**RESOLUTION SETTING HEARING ON REQUEST FROM HUBBELL REALTY COMPANY TO REZONE PROPERTY LOCATED AT 3422 BEAVER AVENUE AND TO APPROVE THE "EDENCREST IN BEAVERDALE" PUD CONCEPTUAL PLAN**

# CONCEPTUAL PLAN EDENCREST IN BEAVERDALE

**Edencrest in Beavertdale**  
PUD Conceptual Building Exterior Designs & Signage

**EDENCREST IN BEAVERDALE PUD CONCEPTUAL PLAN**

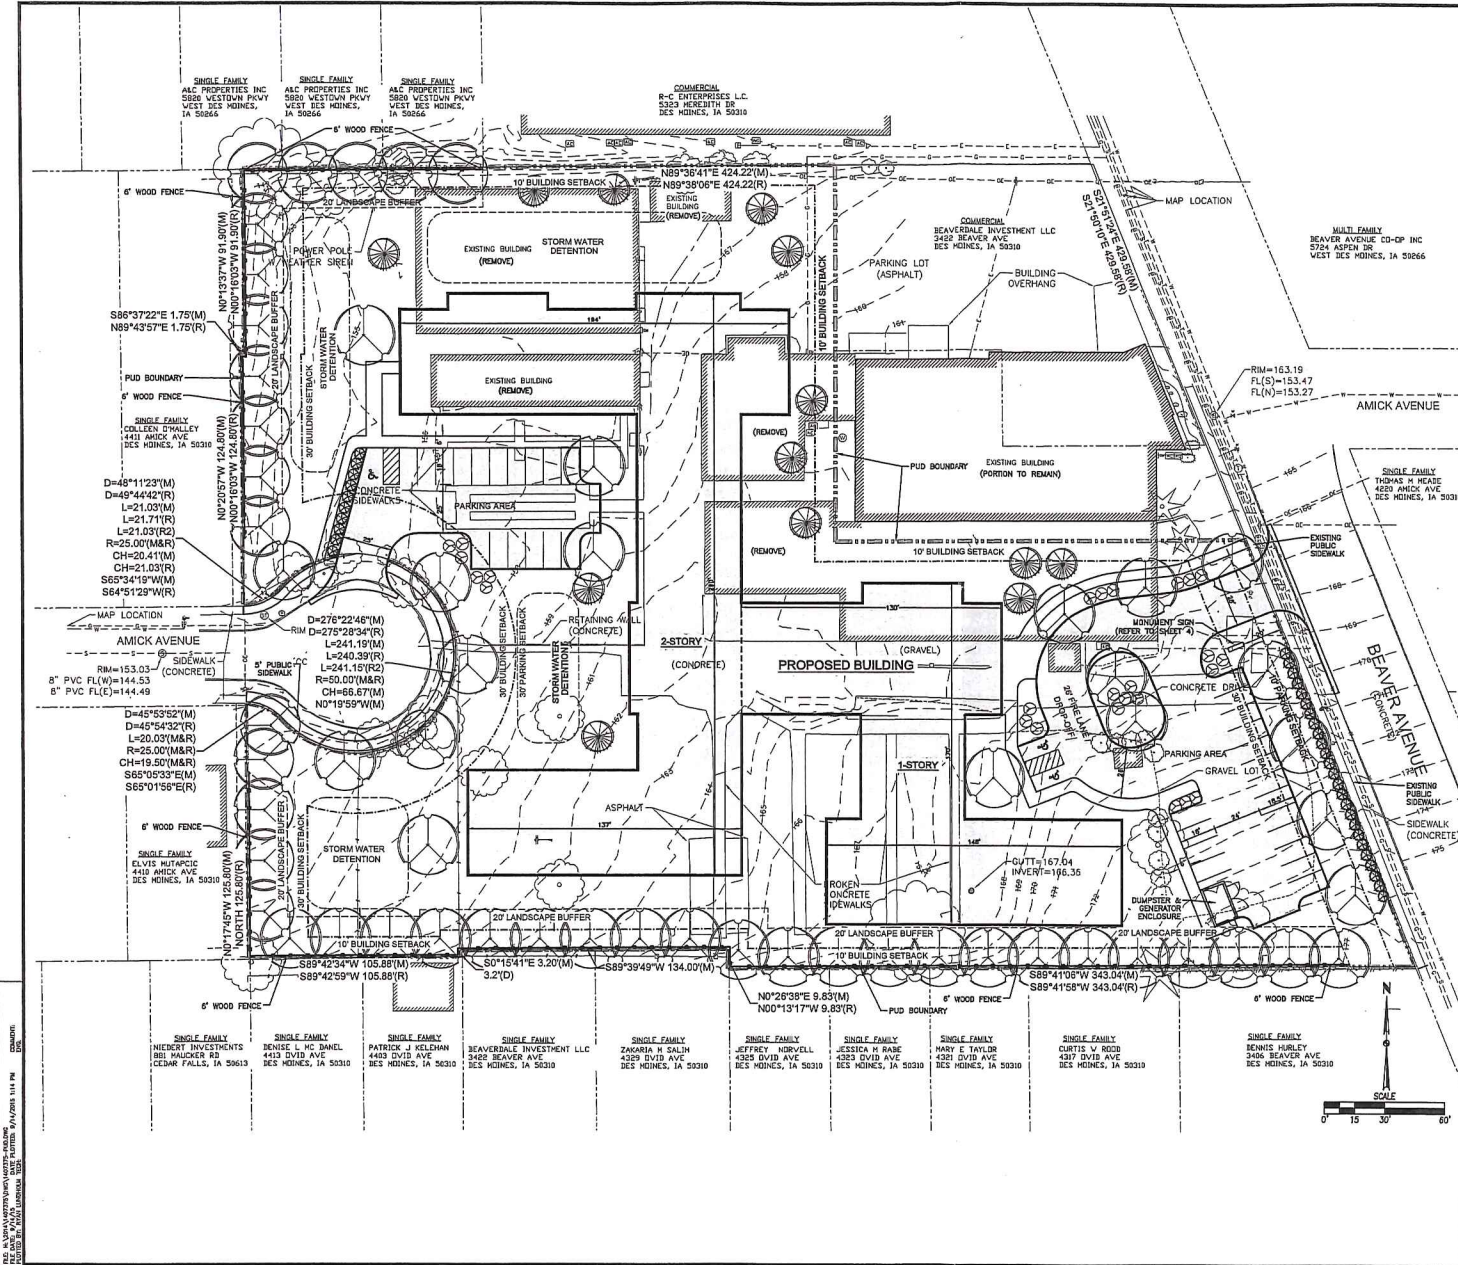
The Conceptual Plan shows plantings throughout the site that generally address these requirements except that there are not any evergreen trees conceptually shown within the bufferyard areas. The number, placement and species will be fully evaluated at the development plan stage. Staff recommends that street trees be provided along all street right-of-ways space at one per 30 feet. This would soften the views of the development from the adjoining residential development in addition to providing the typical aesthetic and environmental benefits association with street trees. Along Beaver Avenue this would include species which may be planted below overhead utilities.

3. The PUD Conceptual Plan needs to contain additional details regarding the service connections to all public utilities.
4. The PUD Conceptual Plan shall demonstrate conceptually that the buffer yard plantings (two overstory trees and six evergreen trees per 100 lineal feet) will be provided. Only overstory trees are shown.

5. The PUD Conceptual Plan shall be revised to reflect a street tree every 30 lineal feet along both the Beaver Avenue and Amick Avenue frontage.
6. The developer shall provide a street lighting design for the Beaver Avenue frontage that complies with the City's street lighting standards.

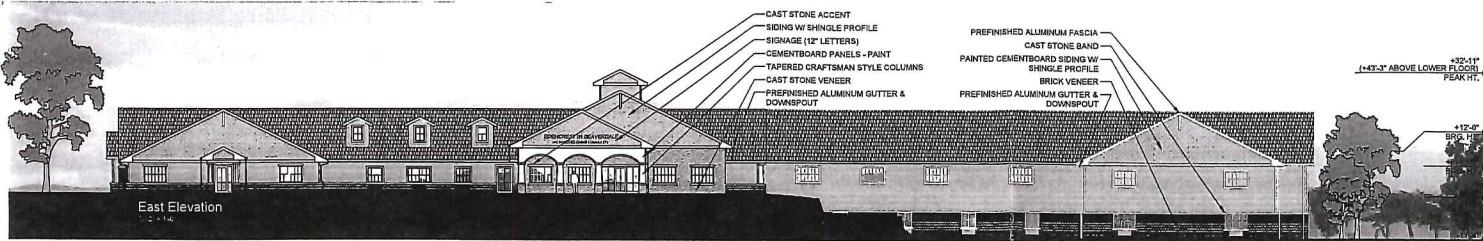
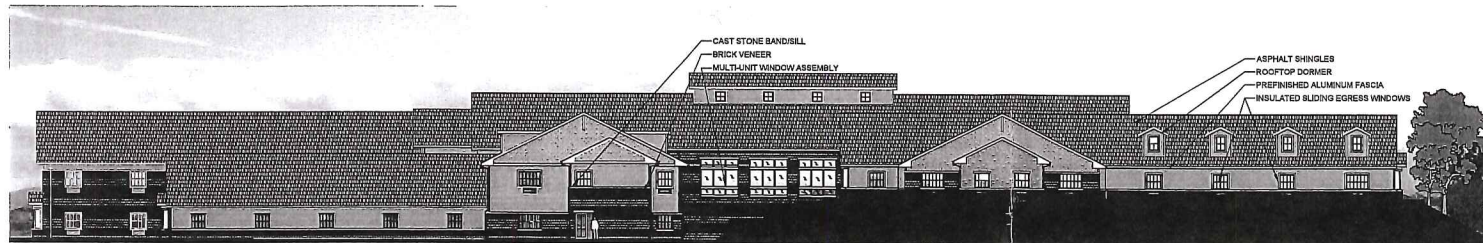
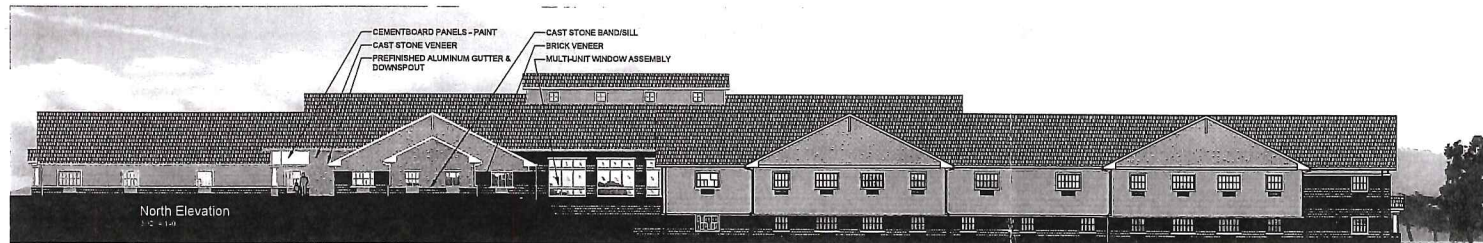
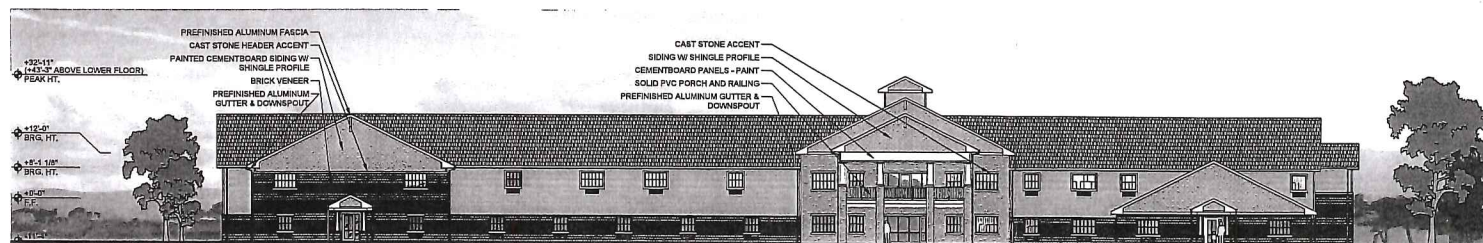
The proposed PUD Conceptual Plan provides elevations that demonstrate the 2-story building would primarily be clad with horizontal overlap and shake cement-board siding, with brick materials on lower portions of the façades and stone material near the primary entrances. In order to be compatible with the character of the surrounding area, staff recommends that the elevations be revised so that at least two-thirds of the surface

Staff also recommends that additional design details be provided to demonstrate that the building will be compatible with the character of the Beavertdale area. Gables on the structure should include exposed rafters, decorative beams or braces, and/or shake-style cement board siding (which has been proposed). All windows on the structure should be double-hung with a multi-light over single pane "craftsman" style and all exterior entry doors on the structure should have multi-light "craftsman" style windows. This is generally being proposed. Staff also recommends that a note be added to state that all windows and exterior entry doors on the structure will have trim surrounds of at least 4 inches in width.

8. The building elevations for the structure shall be revised in accordance with the following and subject to approval by the Planning Administrator:
  - a) At least two-thirds of the surface area of building façades facing Beaver Avenue or Amick Avenue, shall be sided with brick or stone. At least one-third of the building façades facing the side yards shall be sided with brick or stone.

- b) A note shall be added to state that any trim shall consist of cement board material.
  - c) Gables on the structure shall include exposed rafters, decorative beams or braces, and/or shake-style cement board siding.

- d) A note shall be added to state that all windows on the structure shall be double-hung with a multi-light over single pane "craftsman" style.
  - e) A note shall be added to state that all exterior entry doors on the structure shall have multi-light "craftsman" style windows.

- f) A note shall be added to state that all windows and exterior entry doors on the structure shall have trim surrounds of at least 4 inches in width.

- g) A note shall be added to state that the roof will have architectural-type asphalt shingles with a minimum 30-year warranty.

- h) A note shall be added to state that any HVAC equipment shall vent through the roof and rooftop vents shall be complimentary in color to the roofing material. Any rooftop mechanical equipment shall be not be mounted on the Beaver Avenue side of the building and shall be architecturally screened from view.

Monument Sign Elevation  
1/2" = 1'-0"

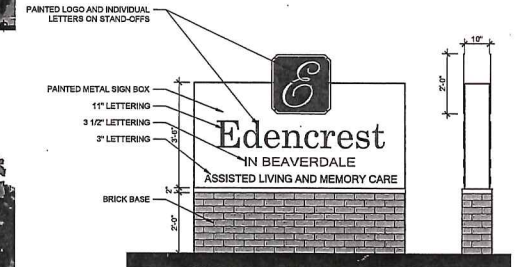
5. **Signage:** The proposed PUD Conceptual Plan indicates that the development will have a monument sign and would allow "R-3" District sign requirements. The total height of the monument sign is 8 feet and is intended to match the character of the development and would be constructed with materials to match the development. It is proposed to be setback 20 feet from Beaver Avenue. Staff recommends that the note be clarified to state that any freestanding signage will be monument-style with bases constructed of brick materials that match the brick or stone materials used on the primary structure.

Sasha Kamper stated according to the plan that the Commissioners have in their packet the sign measures out to be 5' 8" and not 4'.

9. The note on the PUD Conceptual Plan sign requirements regarding monument signs must be clarified to state that any freestanding signage will be monument-style with bases constructed of brick or stone materials that match the masonry materials used on the primary structure.
